# UNITED STATES PATENT AND TRADEMARK OFFICE

10/711,487

<b>Office Action Summary</b>	<b>Application No.</b> 10/711,487	<b>Applicant(s)</b> JOSHI ET AL.	
	<b>Examiner</b> Sunil Singh	<b>Art Unit</b> 3672

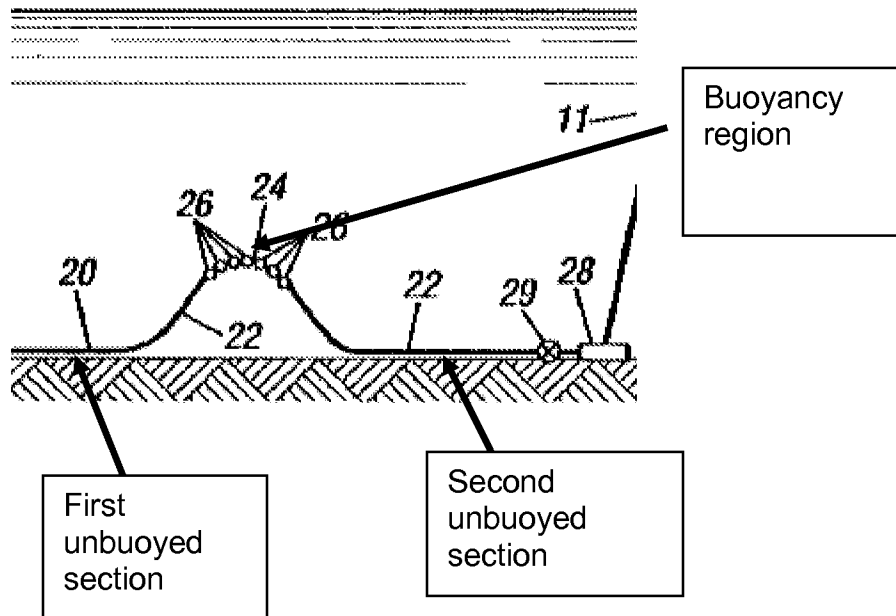
5. Claims 73-76,78-79 rejected under 35 U.S.C. 103(a) as being unpatentable over Richmond et al. '252 in view of Brown '325.

Richmond et al. discloses a pipeline comprising a first unbuoyed section (see drawing below, Fig. 2), second unbuoyed section (see drawing below, Fig. 2), at least one buoyancy section (24,26) disposed between the first and second sections. The positively buoyant inverse catenary section comprises two or more spatially arranged buoyancy solutions. Richmond et al. discloses the invention substantially as claimed. However Richmond et al. is silent about the topographic feature being selected from the group consisting of subsea basins, domes, valleys, cliffs, canyons, escarpments, and combinations thereof. Brown '325 teaches a pipeline traversing a topographic feature being selected from the group consisting of subsea basins, domes, valleys, cliffs, canyons, escarpments and combinations (see Figures). It would have been considered obvious to one of ordinary skill in the art to modify Richmond et al. to include the topographic feature as taught by Brown since such features are indigenous to the seabed environment.

Richmond et al. discloses an apparatus to traverse a seabed topographic feature, comprising: a subsea pipeline constructed to carry fluids across the topographic feature between a first location and a second location; wherein: said pipeline comprising at least one distributed buoyancy region (see drawing above); said pipeline comprising a first unbuoyed pipeline section (see drawing above) extending from said first location on a sea floor to said distributed buoyancy region and a second unbuoyed pipeline section (see drawing above) extending from said distributed buoyancy region to said second
